Planning and Zoning Commission

February 5, 2019

Dallas Center – Grimes Middle School – Site Plan

FOX Engineering has completed the second review for the DC-G Middle School Site Plan dated January 29, 2019. Please address the following comments:

Layout Plans – Sheets C-201 to Sheet C-205

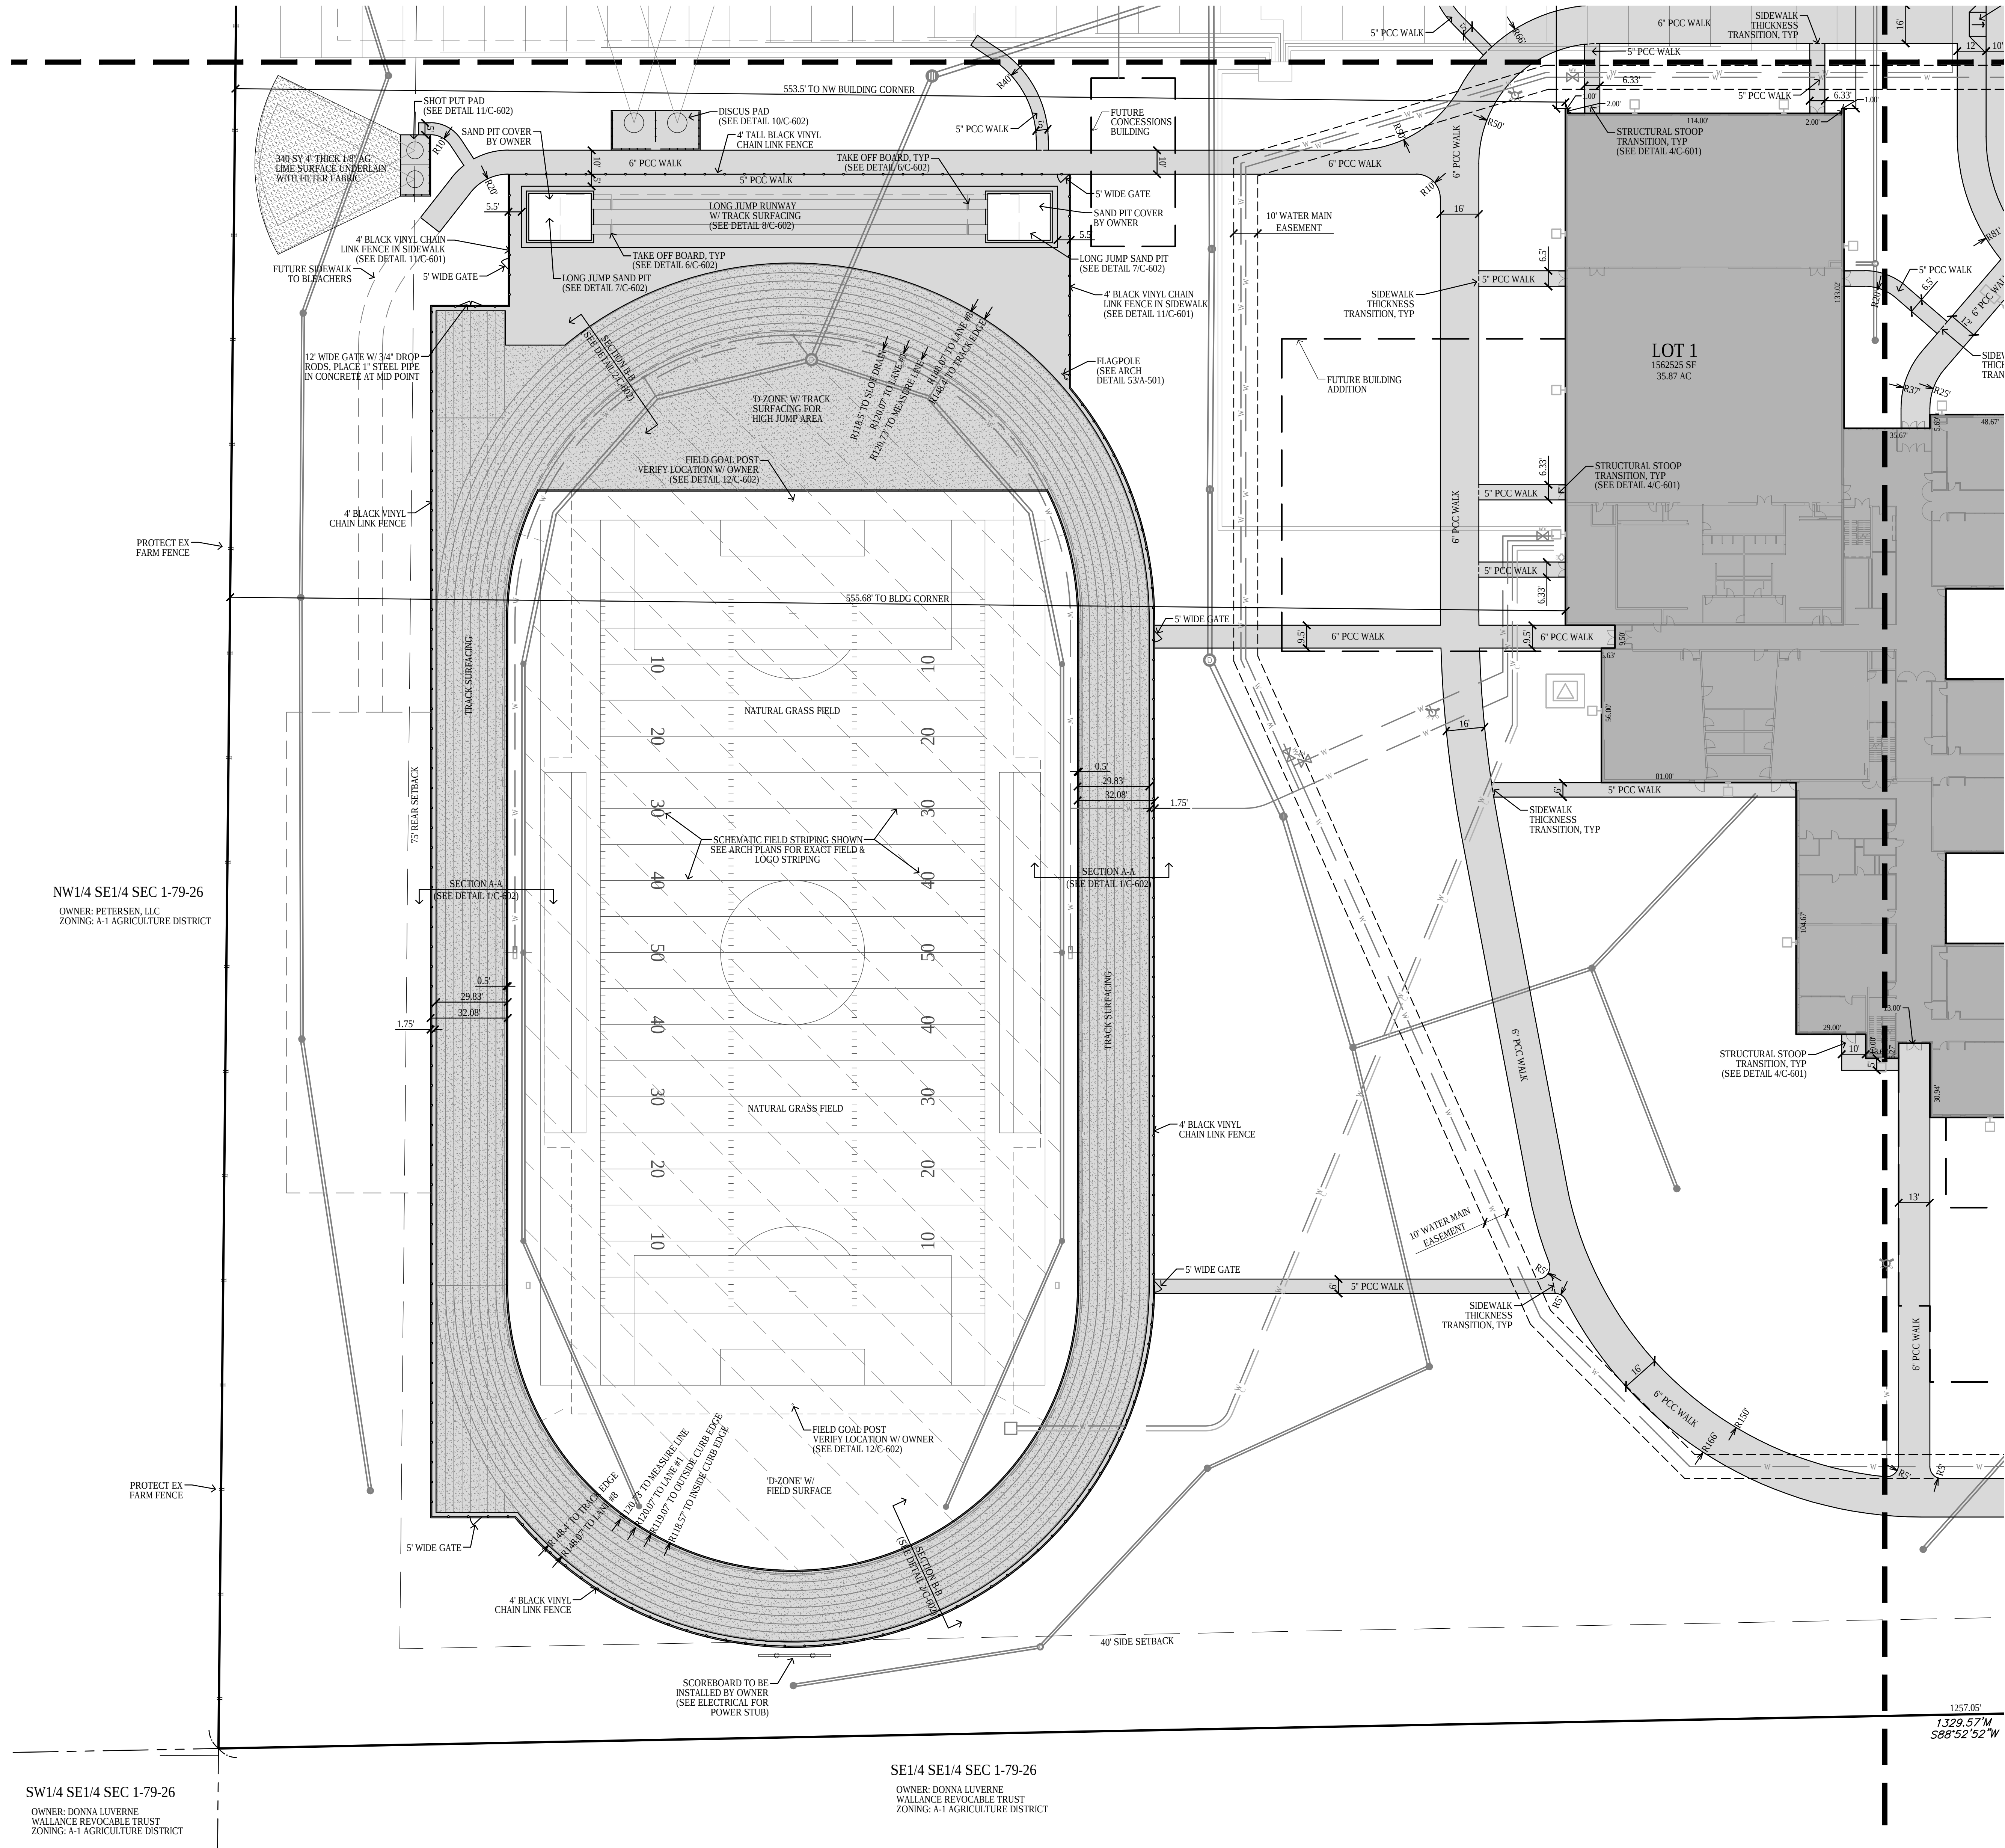
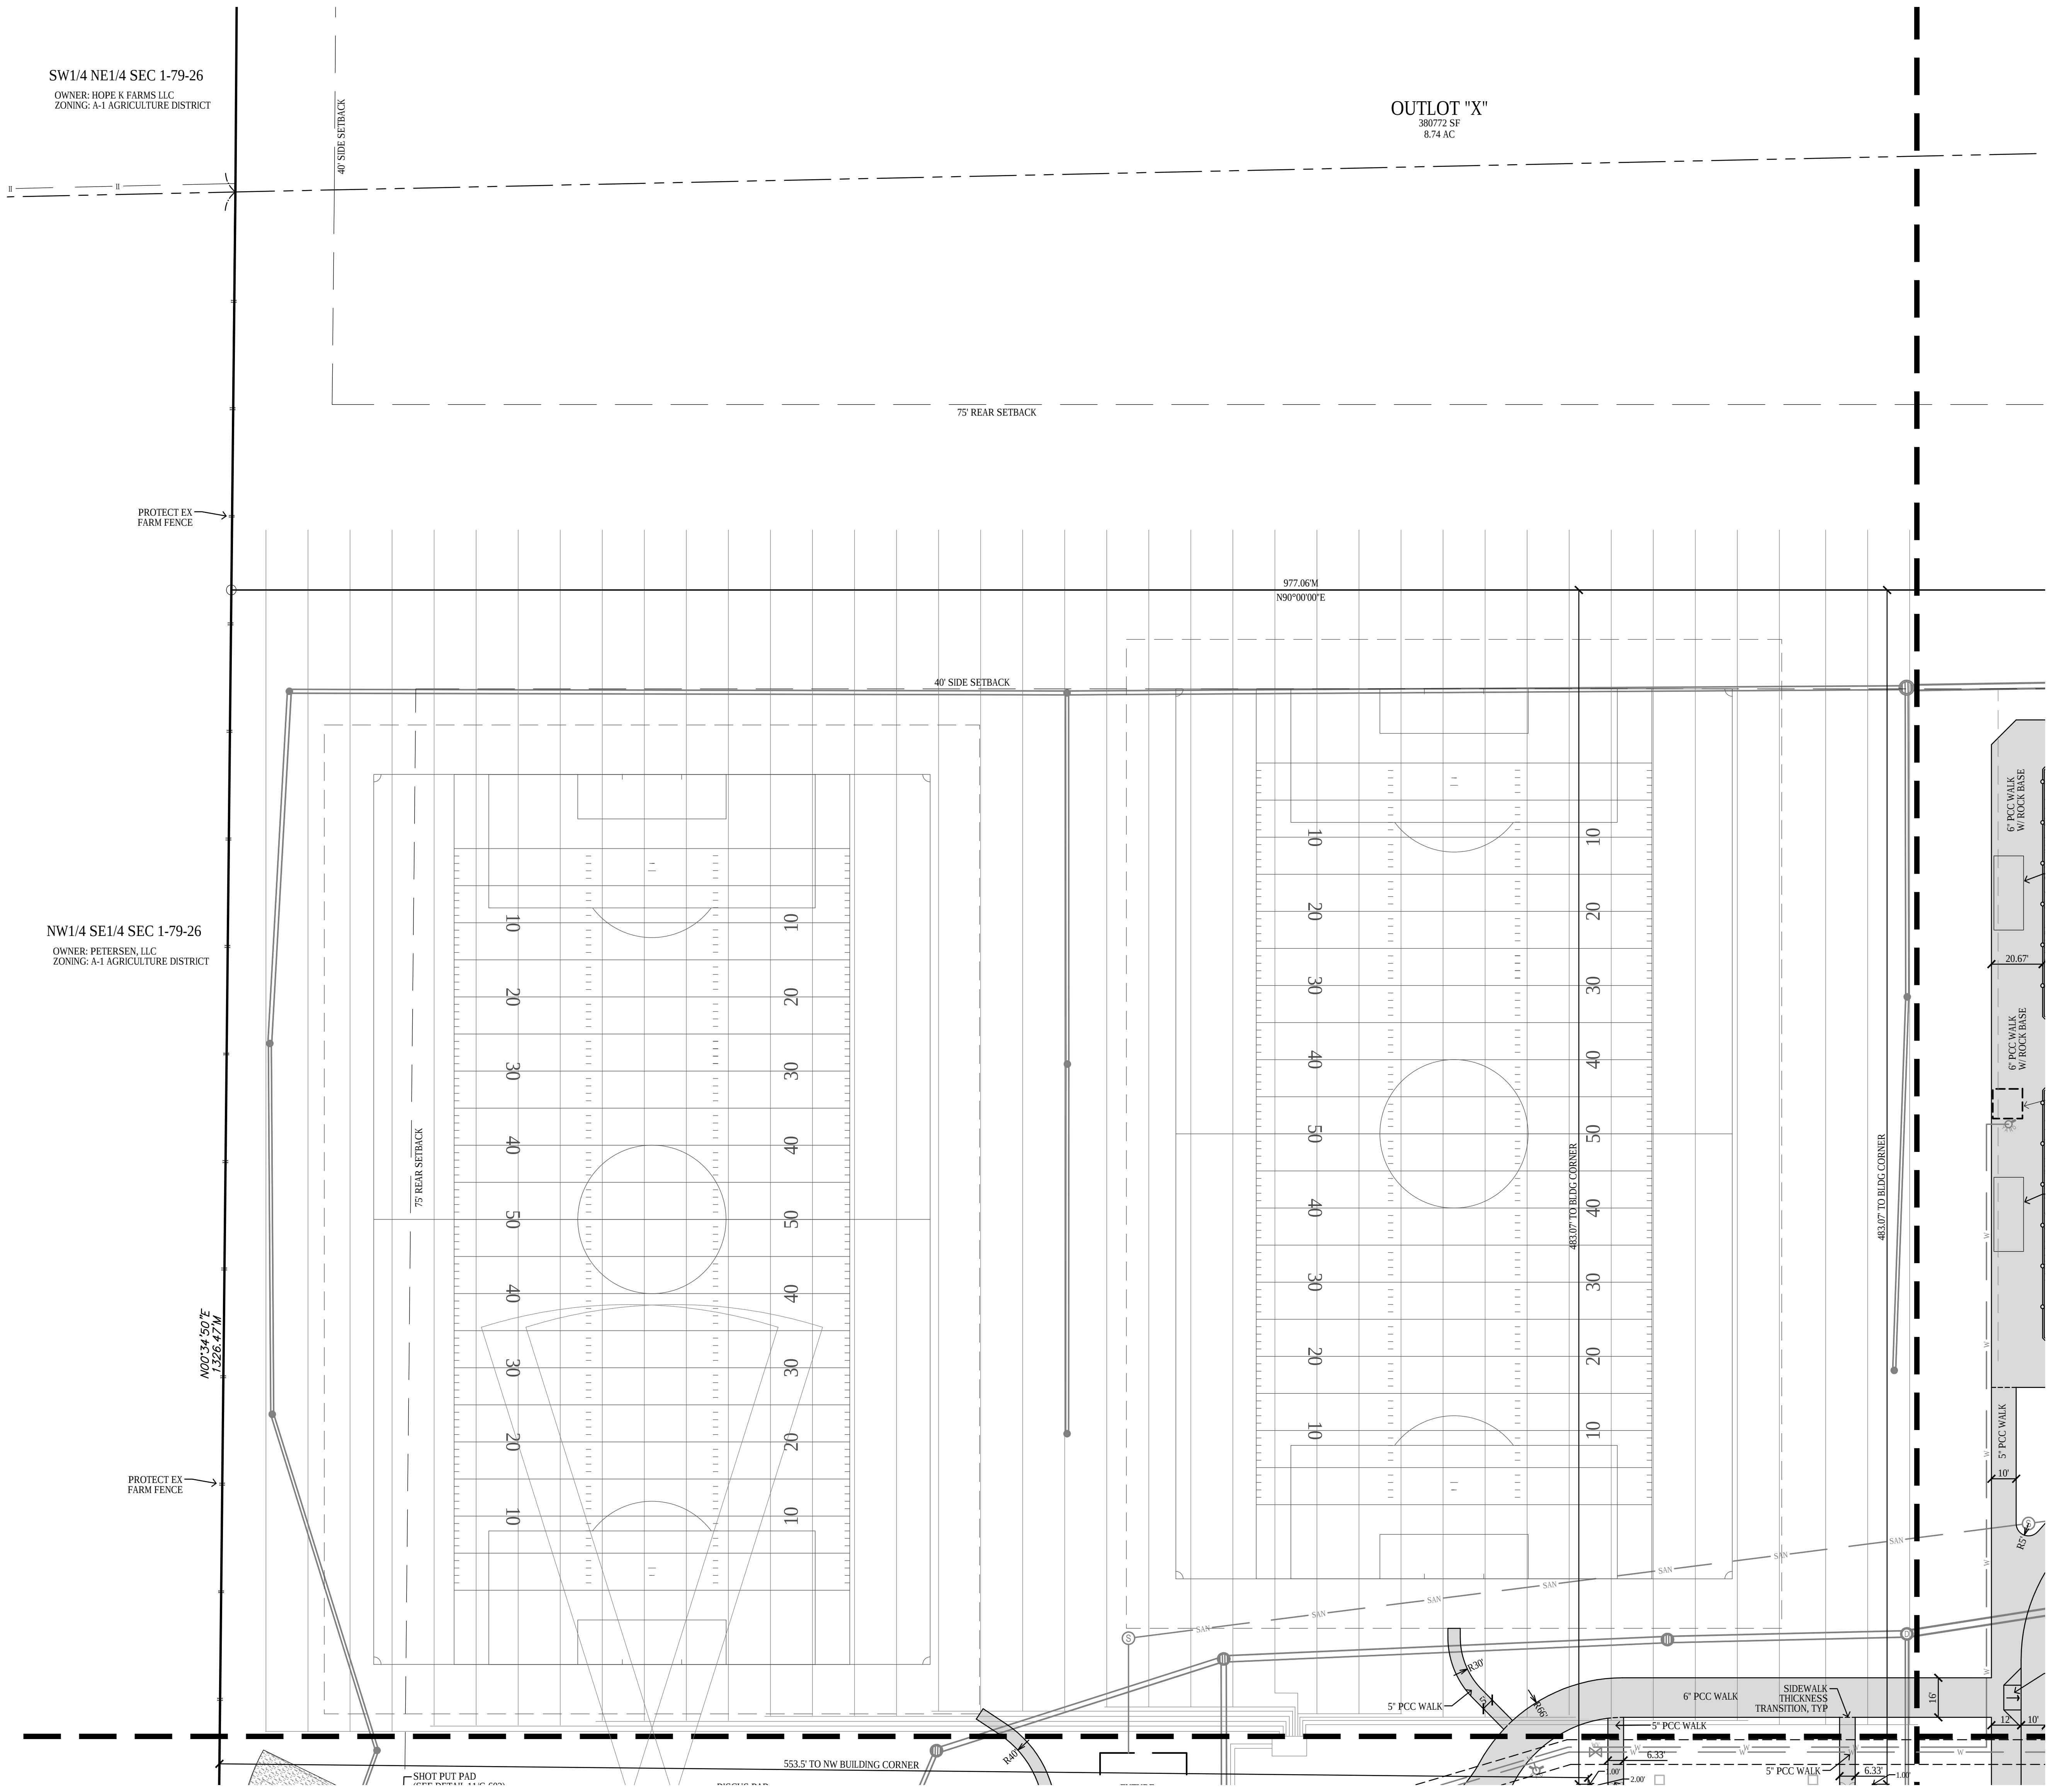
6. Please provide building dimensions around the courtyards on the site plan.
